**ADA ASSESMENT REPORT**  
**COMCARE – RAINBOWS UNITED**  
**603 S. ERIE, WICHITA, KS**  
**Report Date: July 31, 2008**

The following ADA site assessment was performed on July 16, 2008 upon request of April Powell, Project Manager for Sedgwick County Project Services.

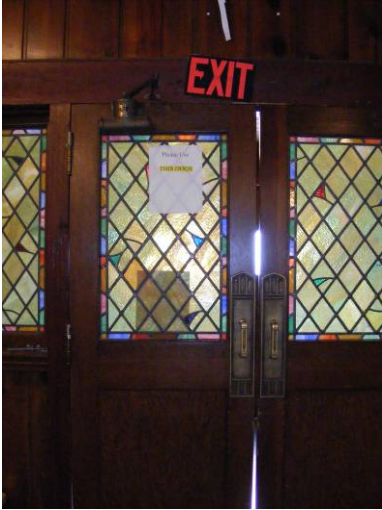
**EXISTING CONDITION:** A ramp exists to provide access to the lowest of the three raised platforms at the back of the facility; however the ramp is not compliant with all ADAAG requirements. The ramp is blocked by furniture (COMCARE staff explained that children were using the ramp to run circles); however, staff explained that the furniture would be moved immediately if a person with a disability entered the facility. The slope of the existing ramp, at 6.9%, is compliant. However the ramp has a number of other structural inconsistencies that require modification.

- **Abrupt changes in level over 1/4” exist at the top and bottom of the ramp.** According to ADAAG, changes in level up to 1/4 in (6 mm) may be vertical and without edge treatment (see Fig. 7(c)). Changes in level between 1/4 in and 1/2 in (6 mm and 13 mm) shall be beveled with a slope no greater than 1:2 (see Fig. 7(d)).  
(ADAAG 4.3.8, 4.5.2)
- **The ramp has a rise of 7” and no handrails are provided.** ADAAG requires that if a ramp run has a rise greater than 6 in (150 mm) or a horizontal projection greater than 72 in (1830 mm), then it shall have handrails on both sides.  
(ADAAG 4.8.5, 4.26)

**RECOMMENDATION:** Modify ramp so that it complies with all ADAAG requirements (ADAAG 4.8).

- Modify thresholds at top and bottom of ramp so that abrupt changes in level do not occur.
- Provide ADAAG compliant handrails. Ensure that the minimum clear width of the ramp is 36” between handrails (ADAAG 4.8.3), and that edge protection is provided at the south side of the ramp (ADAAG 4.8.7).
- Ensure that ADAAG compliant landings exist at the top and bottom of the ramp (ADAAG 4.8.4). ADAAG requires ramps to have clear and level landings at the bottom and top of each ramp. Landings shall have the following features: (1) The landing shall be at least as wide as the ramp run leading to it. (2) The landing length shall be a minimum of 60 in (1525 mm) clear.

Figure 703.4.1 Height of Tactile Characters

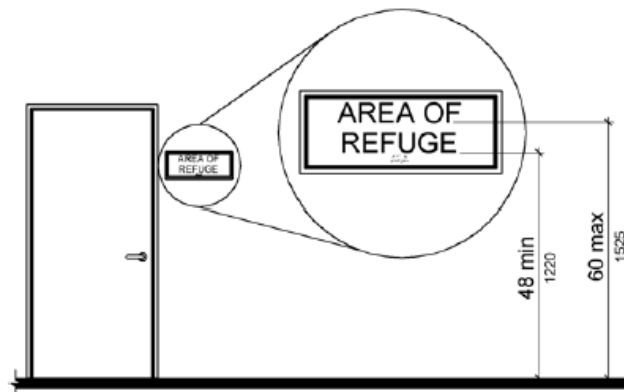
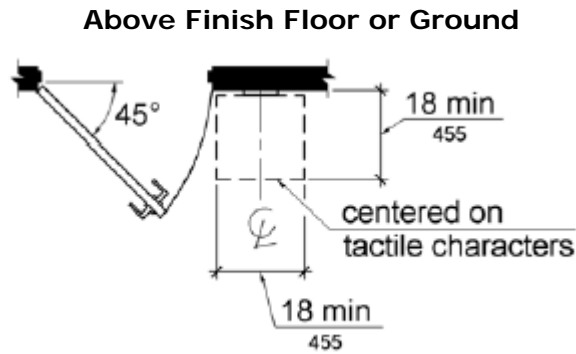
**EXISTING CONDITION:** Exit signs are not also provided in Braille. Signs that identify permanent rooms and spaces (room numbers, exit signs, and restrooms) are required to be provided in Braille, mounted at the latch side of doorway openings. The New ADAAG provides specific guidance on the location of signage. Tactile characters on signs are to be located 48 inches (1220 mm) minimum above the finish floor or ground surface, measured from the baseline of the lowest tactile character and 60 inches (1525 mm) maximum above the finish floor or ground surface, measured from the baseline of the highest tactile character. Where a tactile sign is provided at a door, the sign shall be located alongside the door at the latch side. Where a tactile sign is provided at double doors with one active leaf, the sign shall be located on the inactive leaf. Where a tactile sign is provided at double doors with two active leaves, the sign shall be located to the right of the right hand door. Where there is no wall space at the latch side of a single door or at the right side of double doors, signs shall be located on the nearest adjacent wall. Signs containing tactile characters shall be located so that a clear floor space of 18 inches (455 mm) minimum by 18 inches (455 mm) minimum, centered on the tactile characters, is provided beyond the arc of any door swing between the closed position and 45 degree open position. (ADAAG 4.1.3(16), 4.30 & New ADAAG 703)

Provide Braille signage at all locations where exit signs exist. Mount signage so that it complies with the new ADAAG 703.4.1 and 703.4.2. Use the 60” maximum dimension to establish the mounting height.
